RE: White Lake Retail Building-9197 Highland Road - Preliminary Site Plan Review- 2nd Review

DLZ # 2645-8022-04

**Amended Site Plan / Planned Business Review
for
White Lake Charter Township, Michigan**

Site / Construction Plan Review

**9197 HIGHLAND ROAD
WHITE LAKE, MI.**
SECTION 23, T3N-R8E
WHITE LAKE TOWNSHIP
OAKLAND COUNTY, MICHIGAN
ALTA/NSPS LAND TITLE SURVEY

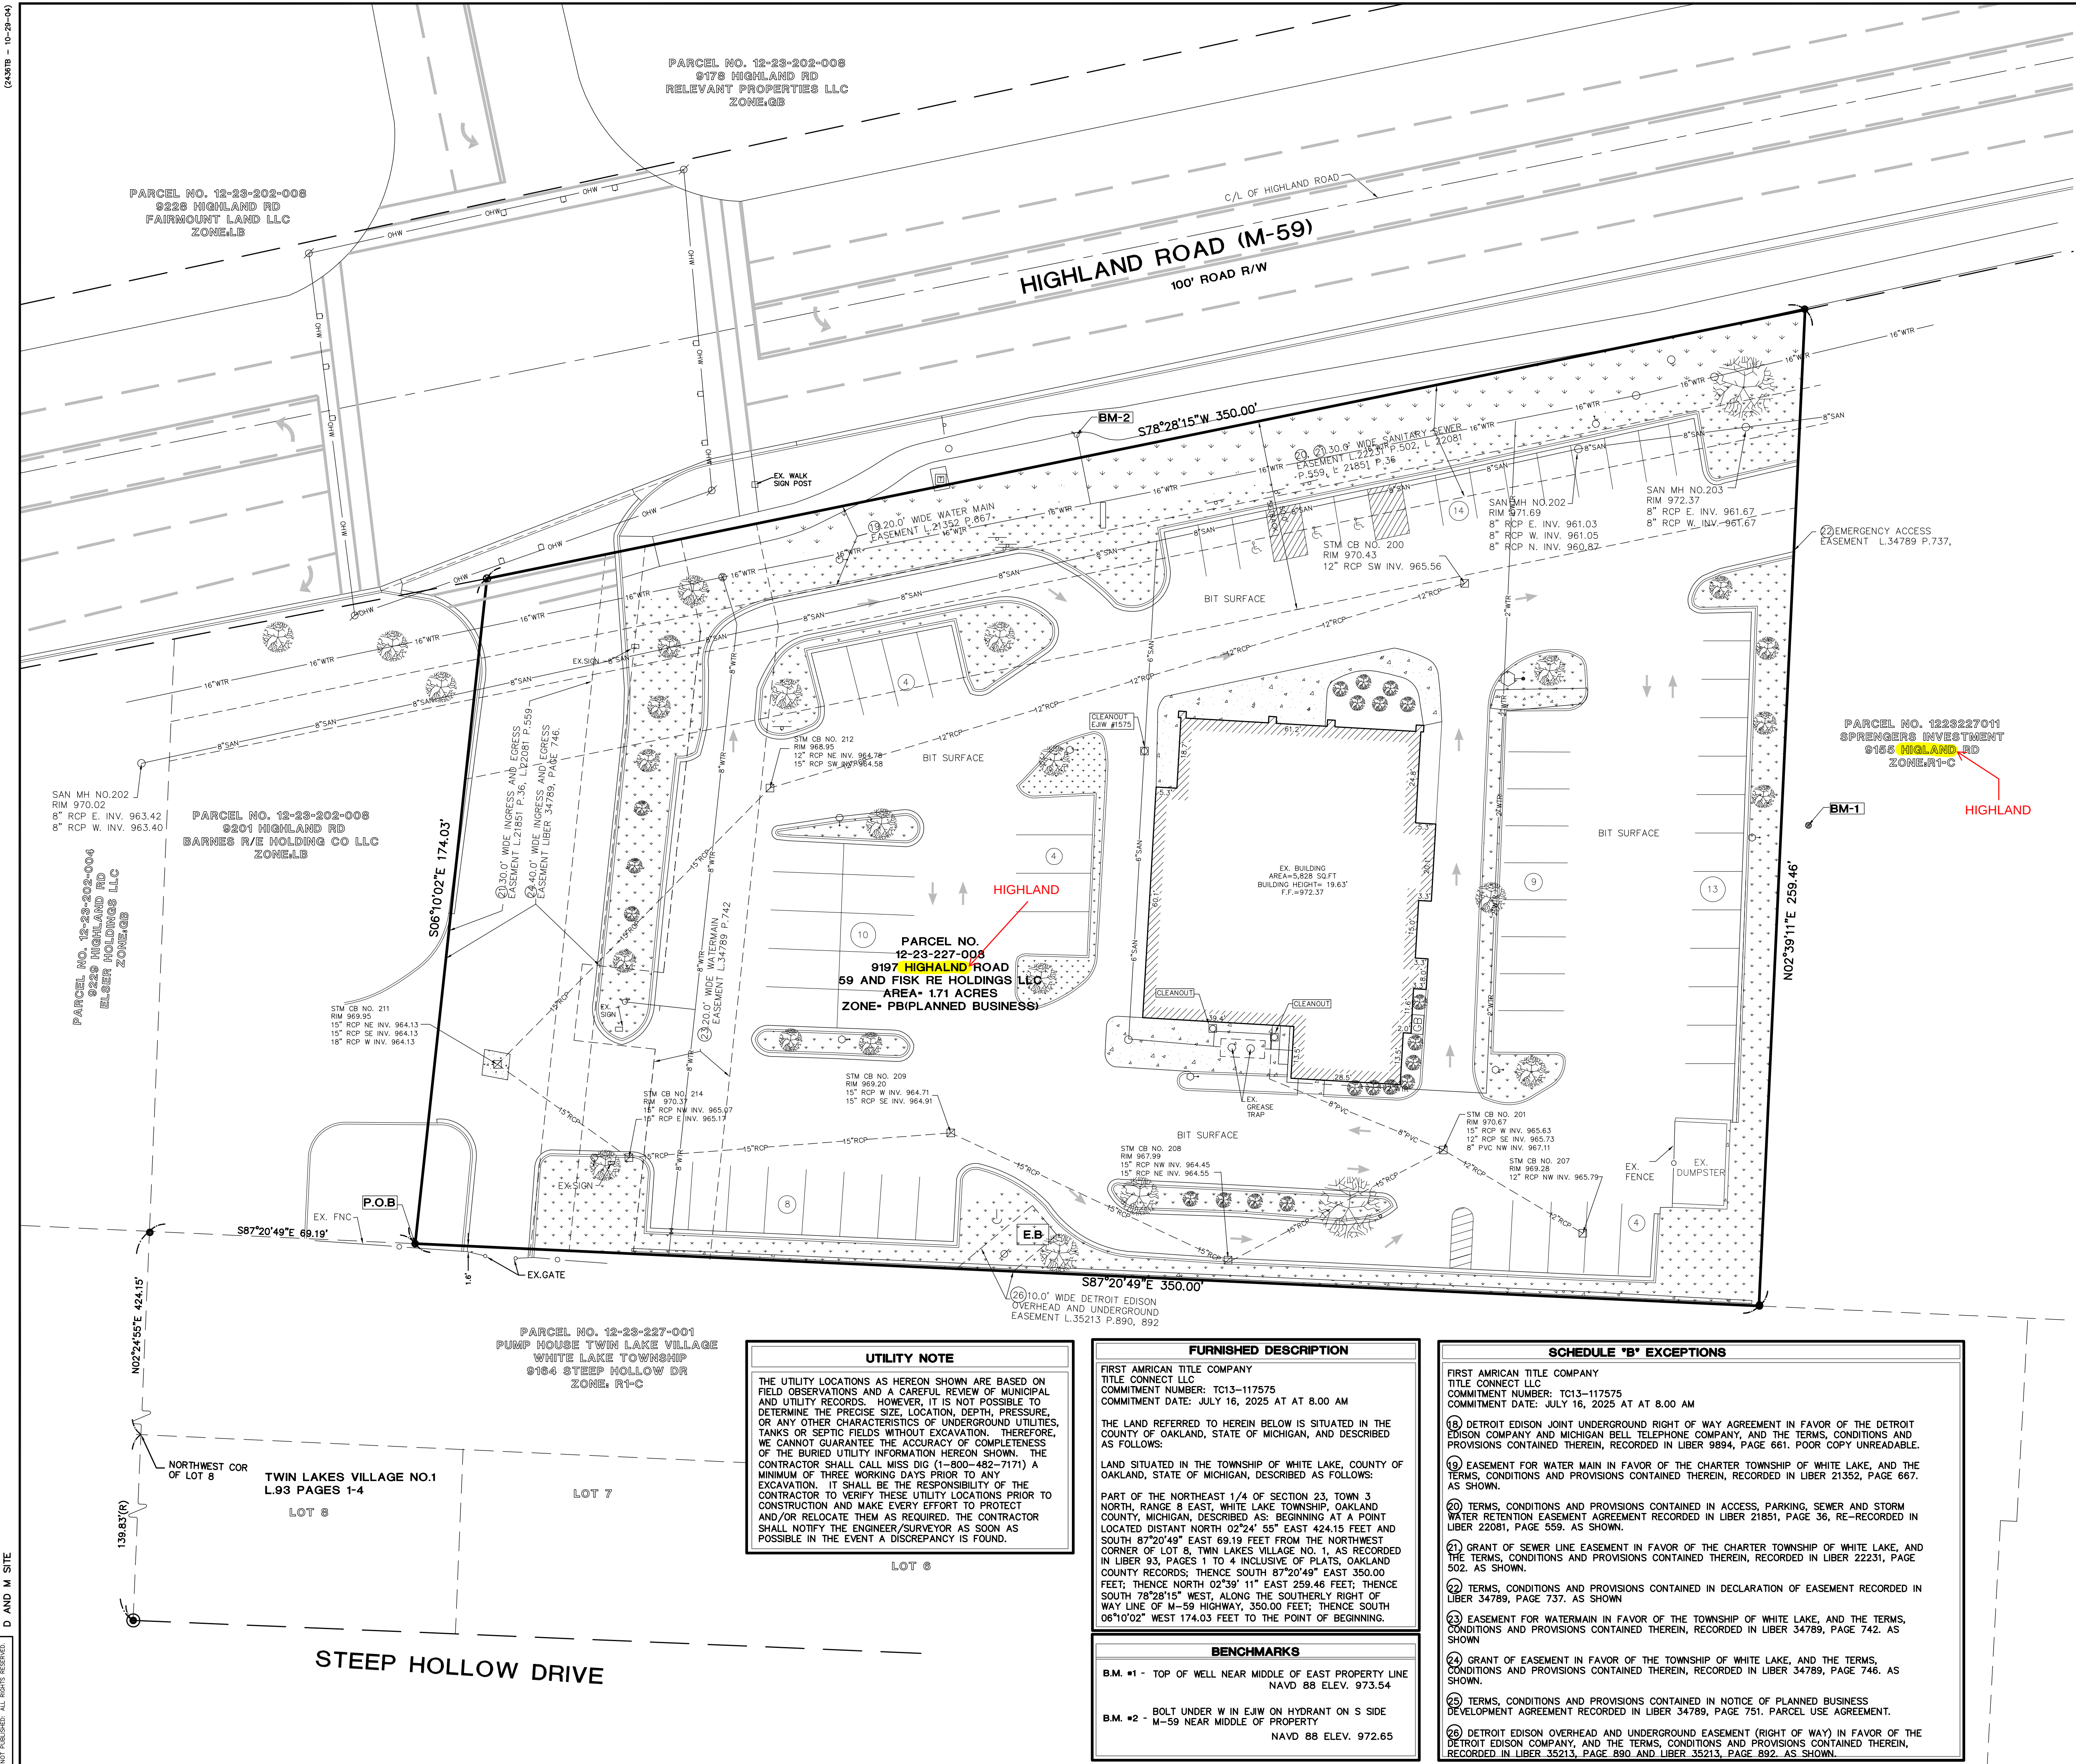
6. *Sheet 1- Please correct spelling of 'Highland' in two areas on this sheet.* **Comment remains; errors are on the parcel callouts for the subject property and the property to the east, see attached markups.**

1. **Comment addressed and removed from this list.**
2. *Sheet 1- There are additional cleanouts for the sanitary sewer lead not shown. In addition, the existing sewer leads from the building are not correctly shown. We recommend the surveyor contact our office for the Wendy's/Tim Hortons's AB drawings.* **Comment addressed.**
3. *The condition of the existing 1000 gallon grease trap shall be evaluated and required maintenance performed. In addition, a 4' diameter monitoring manhole is required prior to discharge to the*

1. *Sheet 1- The layout and diameter of the 6" PVC storm sewer lead from building is incorrect. Lead is shown as 8" diameter and in a different location per AB drawings for Wendy's/Tim Hortons plan. In addition, the diameters of some of the existing storm sewer shown are incorrect. We recommend the surveyor contact our office for the Wendy's/Tim Horton's AB drawings. Comment addressed, storm layout has been updated to match As-Built plans.*
2. Comment addressed and removed from this list.
3. Comment addressed and removed from this list.
4. Comment addressed and removed from this list.
